Access Compliance Report

Public Rights-of-Way

(Curb Ramps)

Intersection ID: N/A	Main Street: SOUTHGROVE_ST	Cross Street: WAVERLY_CENTER_DR	Location: SW
ADA ID: A56DB98F30B2	Ramp Type: Perp	Initial Pass/Fail: Fail	Overall Compliance: No
Severity Score: 21.25			
Codes/Mitigation Info/Possible Solution		Field Measurements/Component Compliance

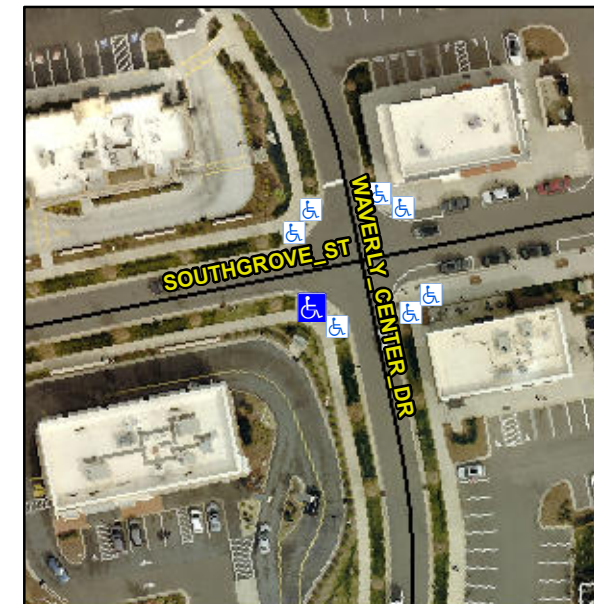
Not Found, R304.5.1, R304.2.2

Compliance	Description	Data	Compliance	Description	Data
N/A	Ramp Length (in)	95.0	No	Ramp Slope (%)	8.6
No	Ramp Width (in)	46.0	Yes	Ramp XSlope (%)	1.4
N/A	Flare Type LT	N/A	N/A	Flare Type RT	N/A
N/A	Flare Slope LT (%)	N/A	N/A	Flare Slope RT (%)	N/A
N/A	Flare Traversable LT?	N/A	N/A	Flare Traversable RT?	N/A
N/A	Landing Length (in)	N/A	N/A	DWS Provided?	N/A
N/A	Landing Width (in)	N/A	N/A	DWS Contrast?	N/A
N/A	Landing Slope (%)	N/A	N/A	DWS Length (in)	N/A
N/A	Landing X Slope (%)	N/A	N/A	DWS Full Width?	N/A
N/A	Landing Curb? (Y/N)	N/A	N/A	DWS Offset (in)	N/A
N/A	Shared Landing?	N/A			
N/A	Gutter Ponding?	N/A	N/A	Gutter Slope (%)	N/A
N/A	Gutter Lip Ht (in)	N/A	N/A	Gutter X Slope (%)	N/A
N/A	Painted X Walk1?	No	N/A	Painted X Walk2?	N/A
	X Walk 1 Direction	To N		X Walk 2 Direction	N/A
N/A	X Walk 1 Width (in)	N/A	N/A	X Walk 2 Width (in)	N/A
	X Walk 1 Slope (%)	3.6		X Walk 2 Slope (%)	N/A
	X Walk 1 X Slope (%)	1.4		X Walk 2 X Slope (%)	N/A

Remove & Replace Entire Ramp.
